JOB	Barr Middle School
	Roof reinforcements

TITLE	ROOF REINFORCEMENTS
-------	---------------------

JOB NO.	BILL NO.	EXTRA NO.	DRWG NO.
2346	B 01	X	E7

ROOF - PLAN VIEW
SCALE: 3/32"=1'-0"

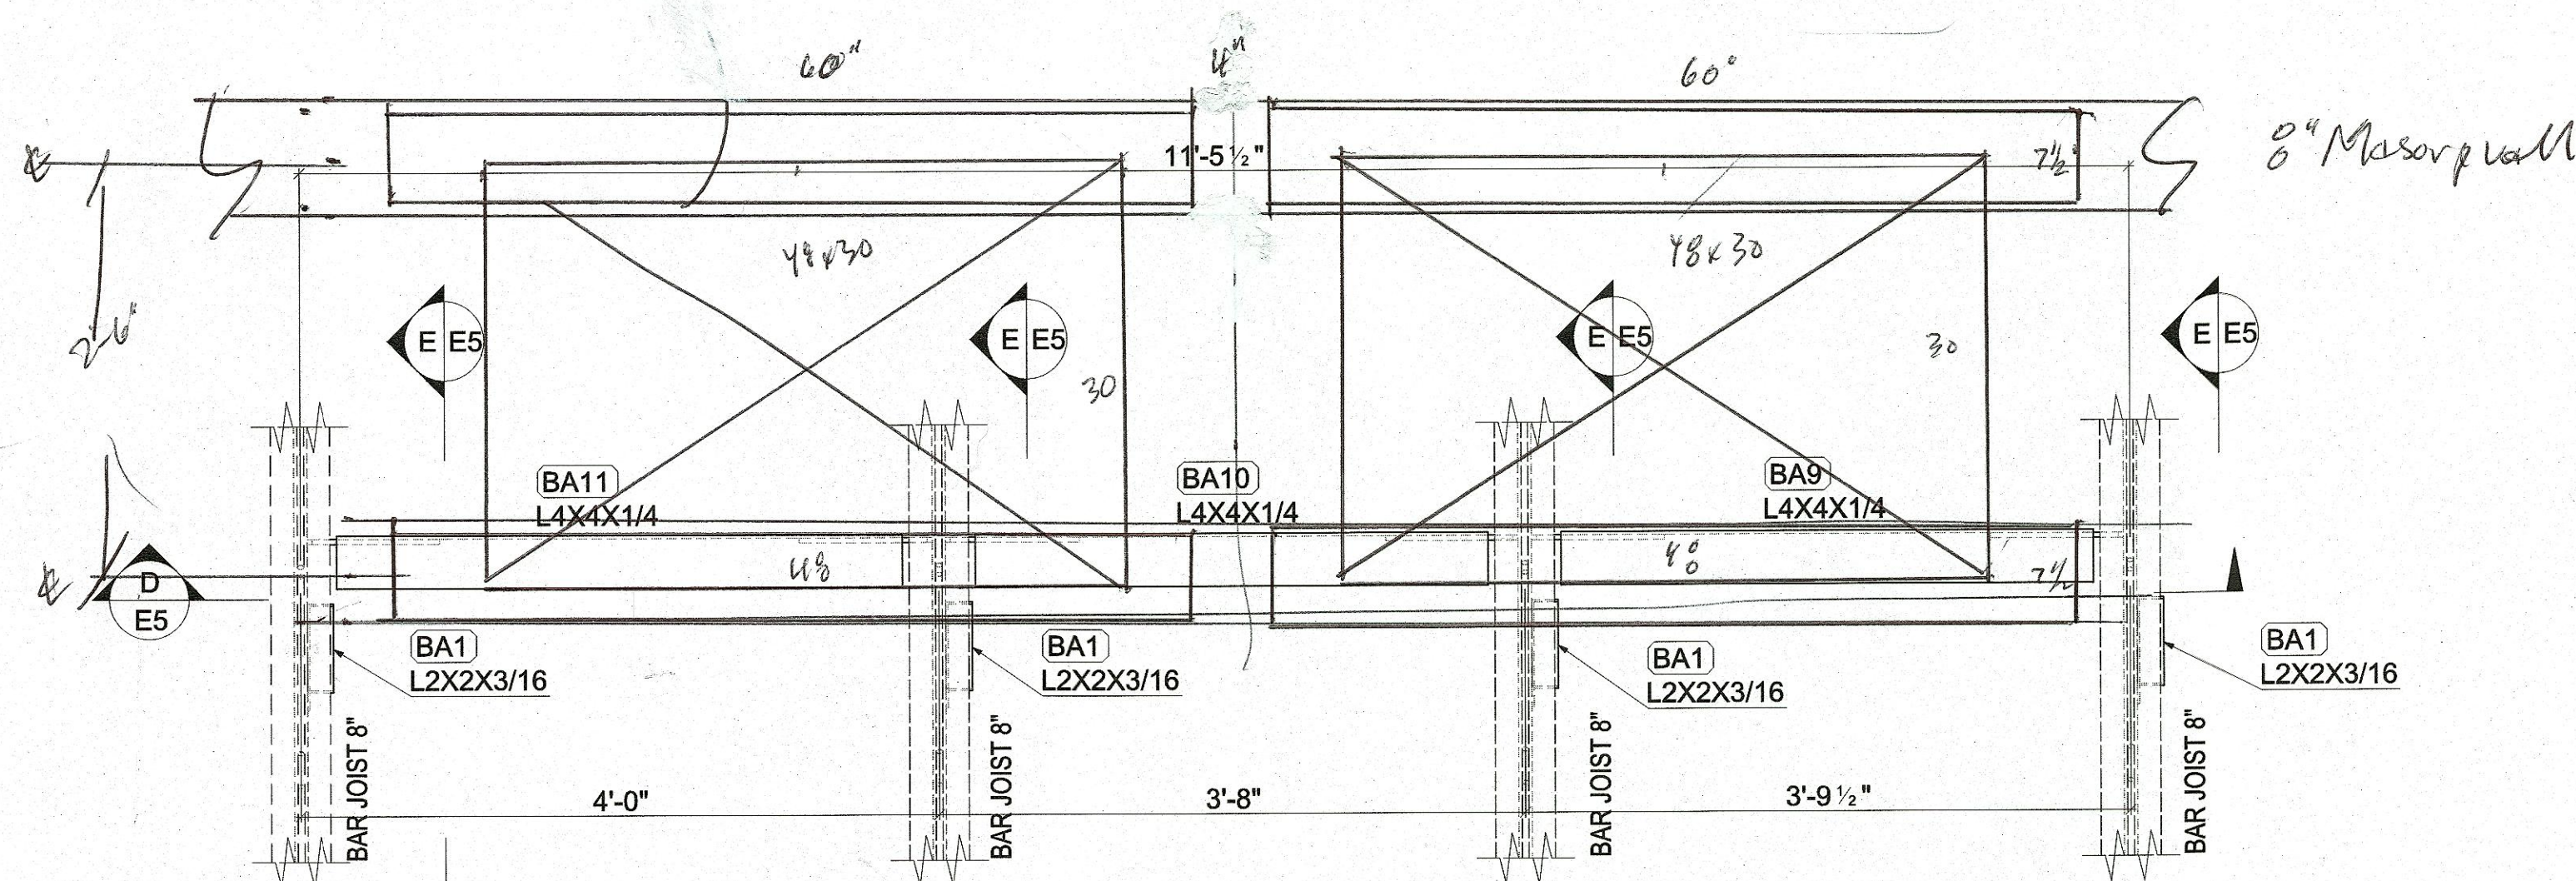
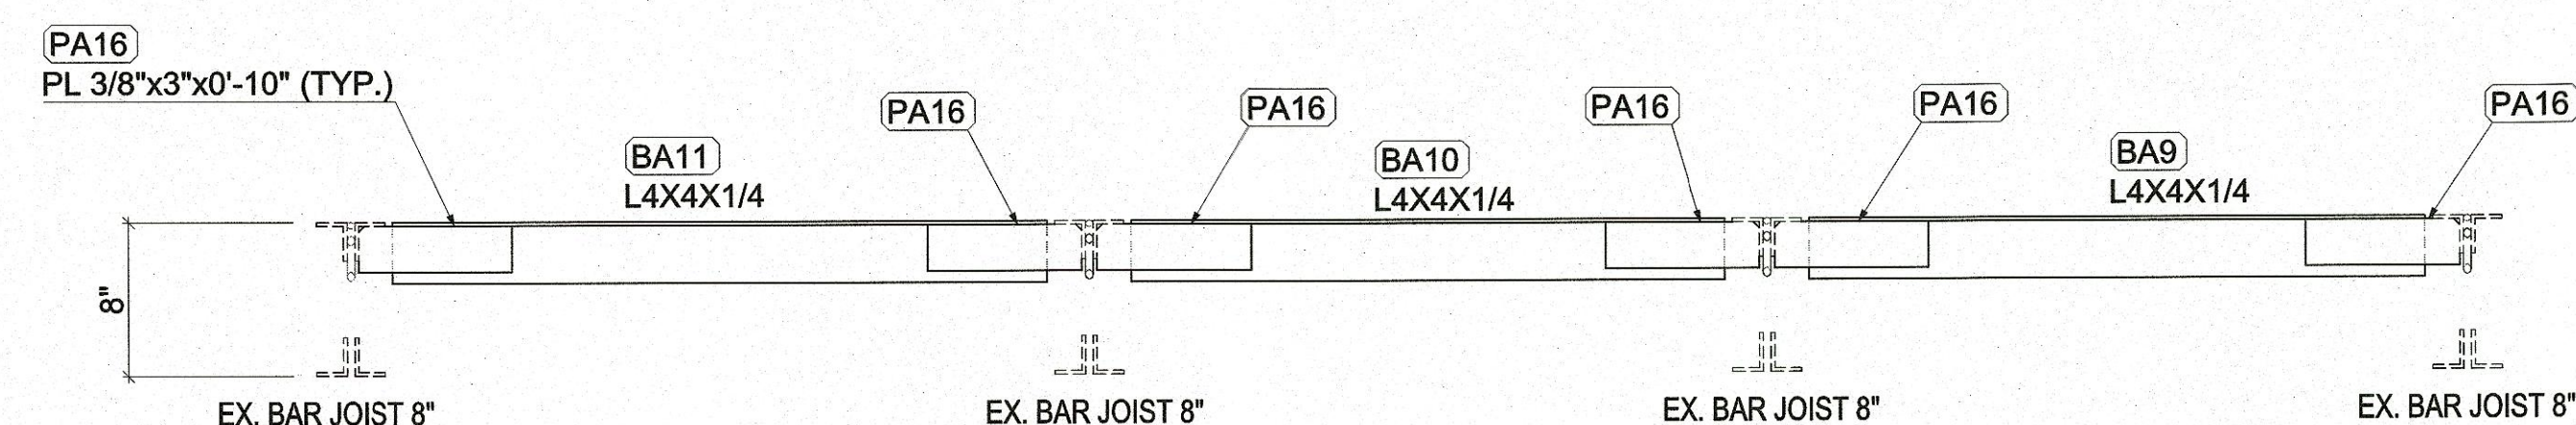
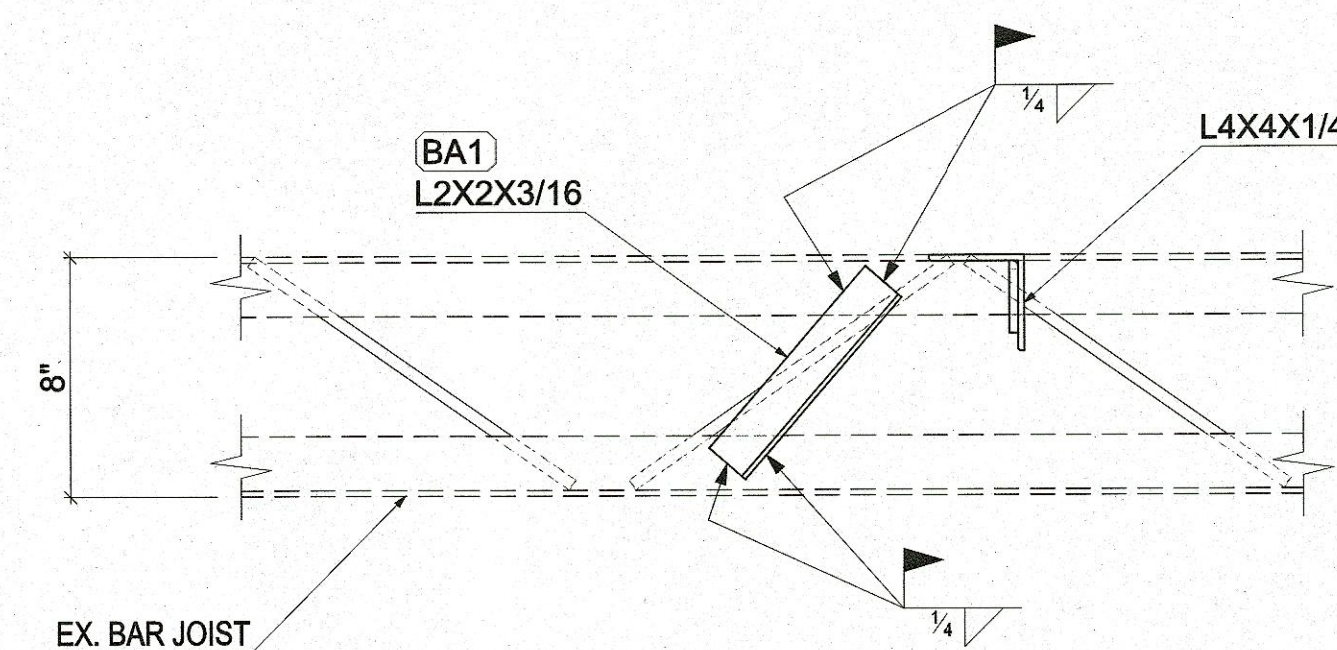
Conflict w/ a Old Existing Fan
Then Fan is Abandon
Rafter needs to Remove
on d Patch Deck
